November 6, 1997

Customer Service Bulletin

Units Affected:

07-319-xx AC Termination board as viewed from inside lower chassis

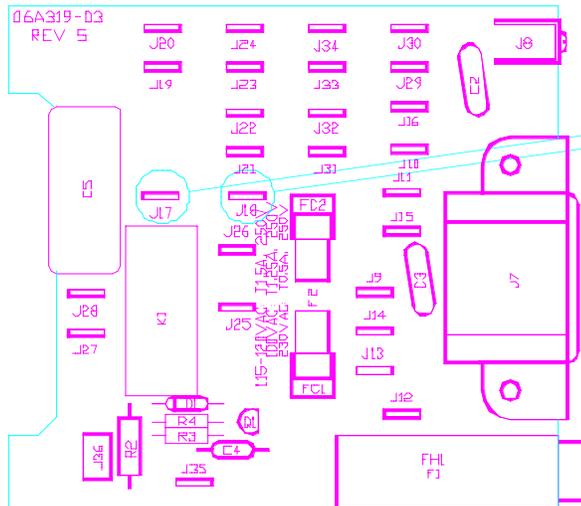
Concern:

AC mains fuse for filament transformer would fail prematurely during normal operation when tuning unit on as a result of a design change to use IEC approved fuse beginning with 1/1/97 production. Replacement with larger value fuse would solve false tripping problem but would not always provide adequate protection against damage during severe fault condition.

Add two each 3A in-rush current limiters (ICL's) that have been prepared with .187" Fast-on connectors (SLME part number 97-123-23) to the filament transformer primary circuit as follows:

1. Disconnect the AC power from the unit.
2. Remove lower chassis assembly from cabinet and view from bottom.
3. On the 07-319-xx AC termination PC board, remove blue and gray leads from tabs J17 and J18.
4. Add one 97-123-23 ICL assembly in series with the blue transformer lead and tab J17, and one in series with the gray lead and J18 by attaching the female Fast-on connector of ICL to the tab on the printed circuit board and the male Fast-on to transformer lead.
5. Secure the assembly with a cable tie to other AC wires so that no leads are touching other parts.
6. Replace the fuse (F2) with a T1.25A (SLME part number 23-512-05).
7. Remove any fuse label so that "100VAC T1.25A" is visible on the printed circuit board.
8. Reassemble and check out unit for proper operation.

Add one 97-123-23 ICL assembly in series with J17 and the blue transformer lead and one in series with J18 and the gray transformer lead.
